The licensee is authorized to operate the Donald C. Cook Nuclear Plant, Unit No. 1, at steady state reactor core power levels not to exceed 3304 megawatts (thermal).

The Technical Specifications contained in Appendices A and B, as revised through Amendment No. 273, are hereby incorporated in the license. The licensee shall operate the facility in accordance with the Technical Specifications.

AMENDMENT NO. 88, 1/87  
273

FIGURE 3.4-2  
 REACTOR COOLANT SYSTEM PRESSURE - TEMPERATURE LIMITS VERSUS 60°F/HR RATE  
 CRITICALITY LIMIT AND HYDROSTATIC TEST LIMIT

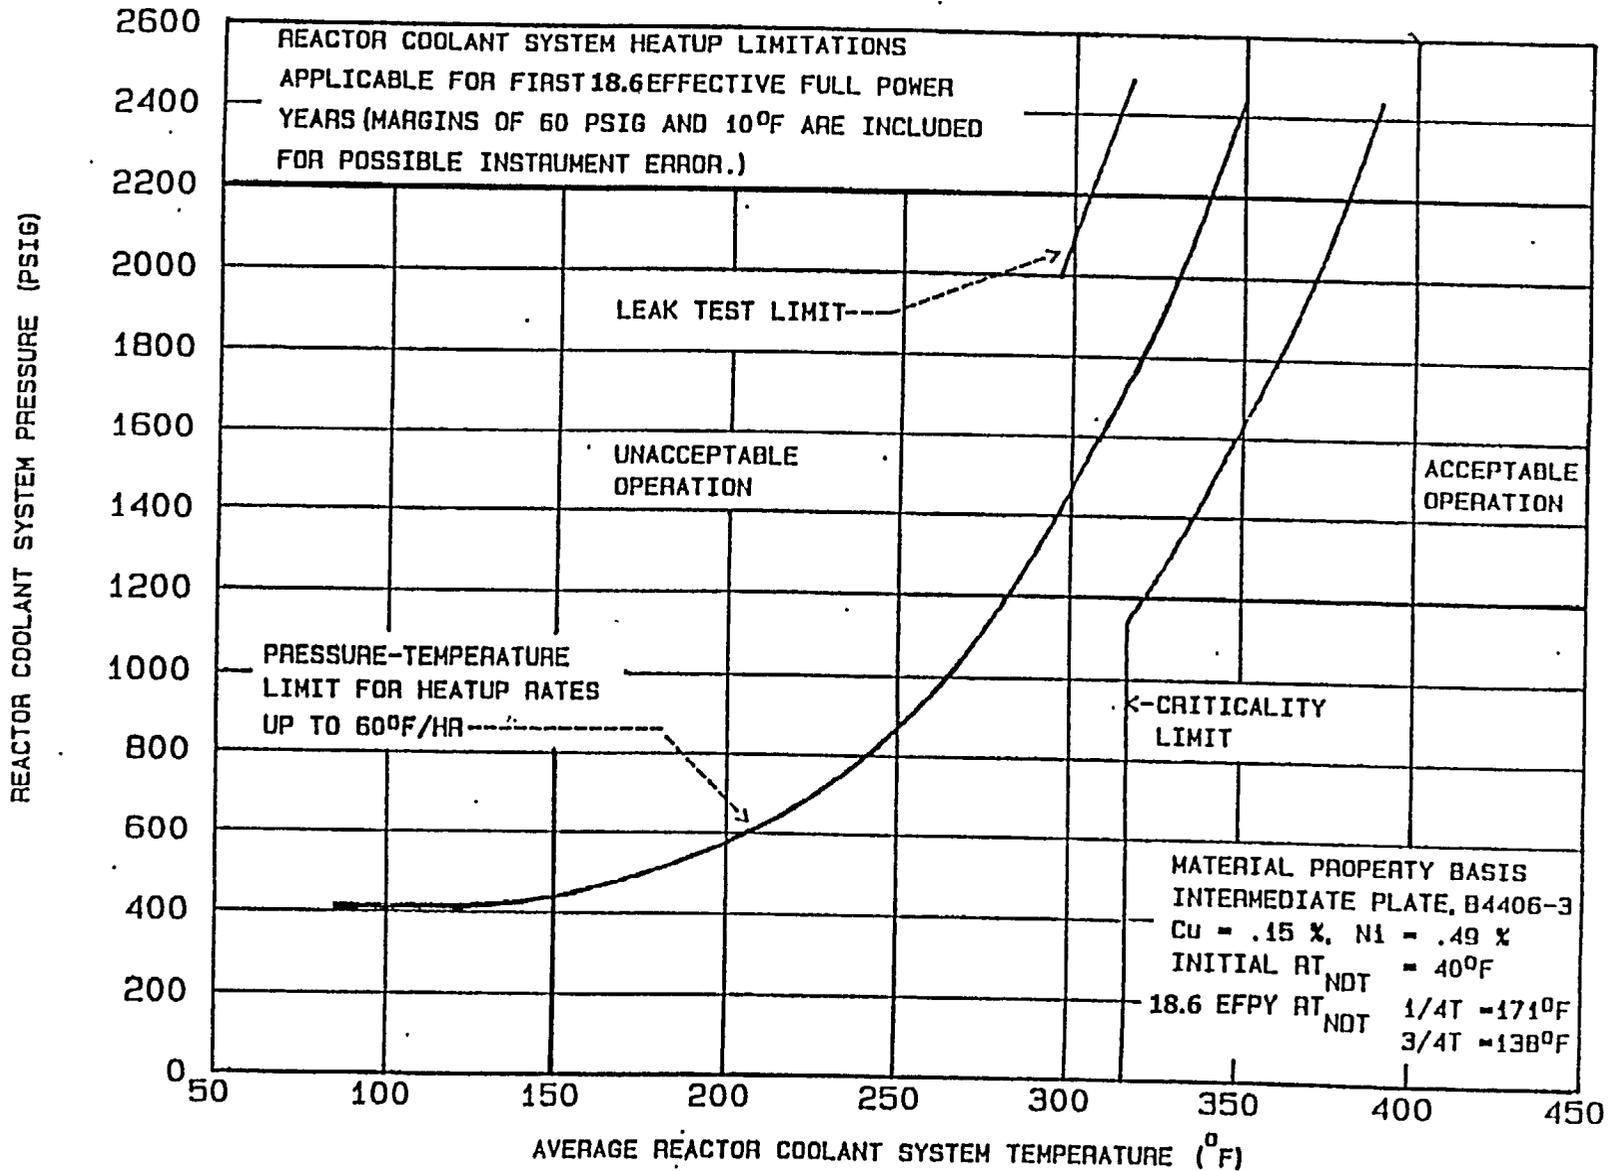
The heatup limit curve, Figure 3.4-2, is a composite curve which was prepared by determining the most conservative case, with either the inside or outside wall controlling, for any heatup rate up to 60°F per hour. The cooldown limit curves of Figure 3.4-3 are composite curves which were prepared based upon the same type analysis with the exception that the controlling location is always the inside wall where the cooldown thermal gradients tend to produce tensile stresses while producing compressive stresses at the outside wall. The heatup and cooldown curves were prepared based upon the most limiting value of the predicted adjusted reference temperature at the end of 18.6 EFPY.

The pressure-temperature limit lines shown on Figure 3.4-2 for reactor criticality and for inservice leak and hydrostatic testing have been provided to assure compliance with the minimum temperature requirements of Appendix G to 10 CFR 50.

FIGURE 3.4-3

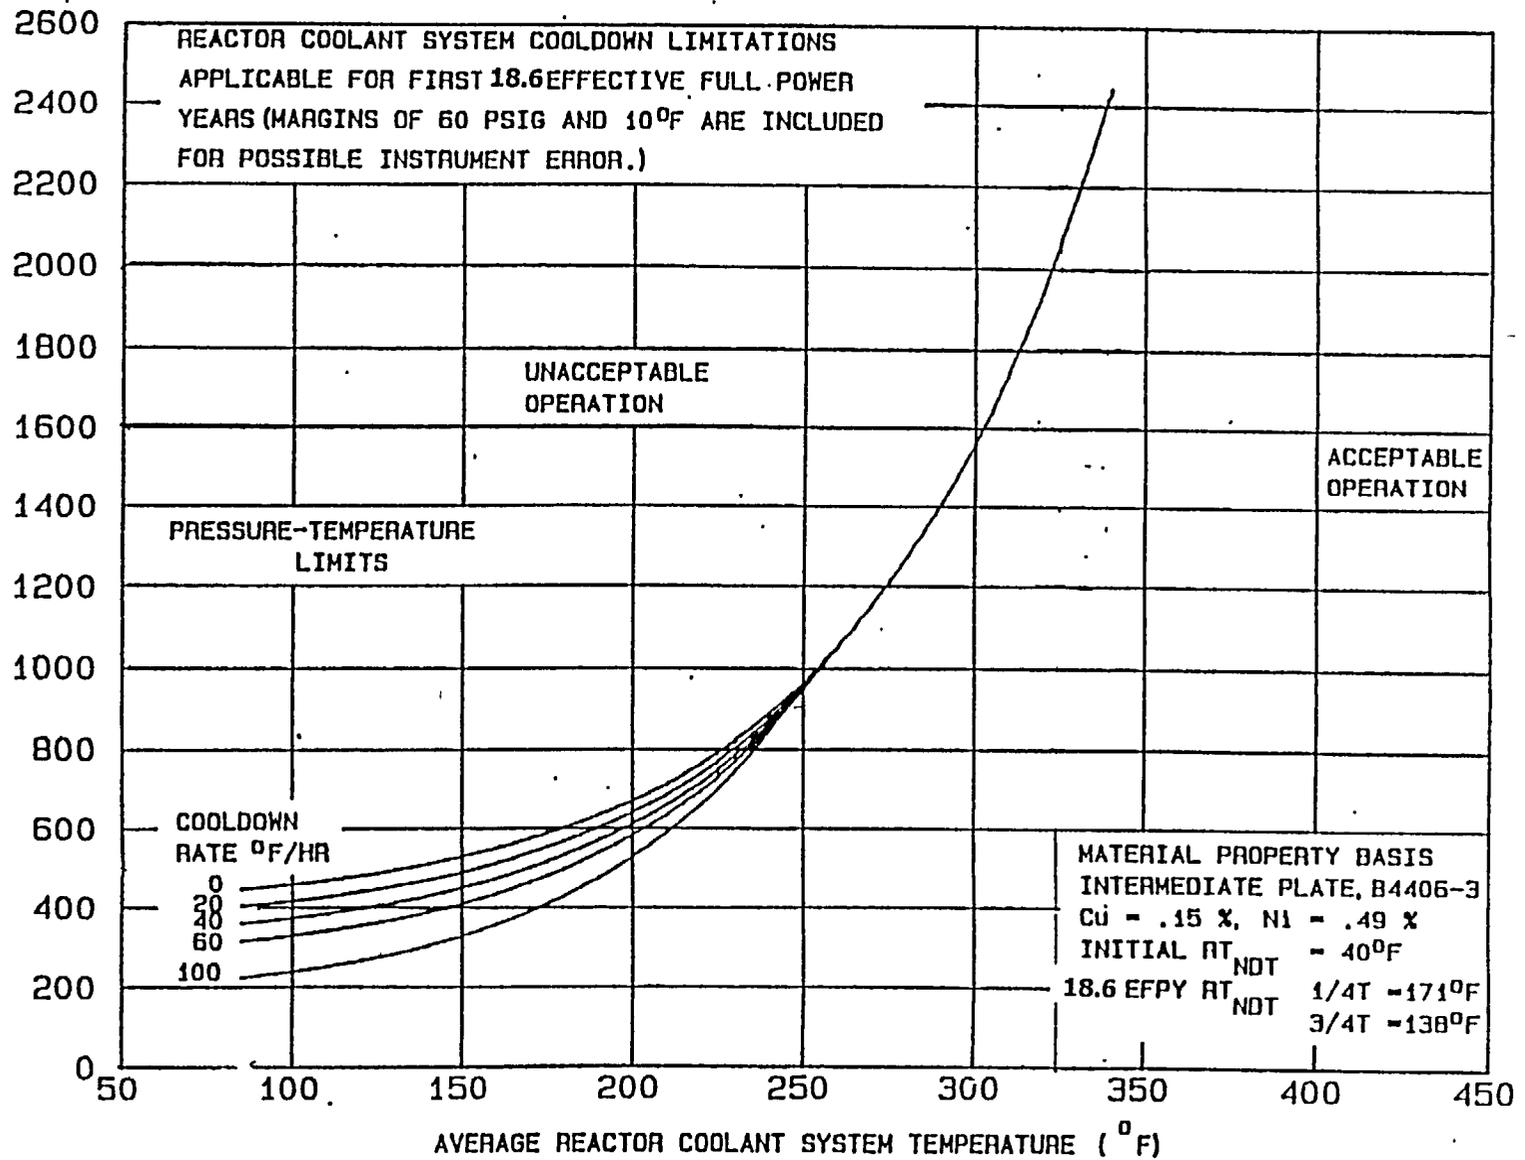
Reactor operation and resultant fast neutron ( $E > 1$  Mev) irradiation will cause an increase in the  $RT_{NDT}$ . Therefore, an adjusted reference temperature, based upon the fluence, and the copper and nickel content of the material must be predicted. The heatup and cooldown limit curves of Figures 3.4-2 and 3.4-3 include the adjusted  $RT_{NDT}$  at the end of 18.6 EFPY, as well as adjustments for possible errors in the pressure and temperature sensing instruments.
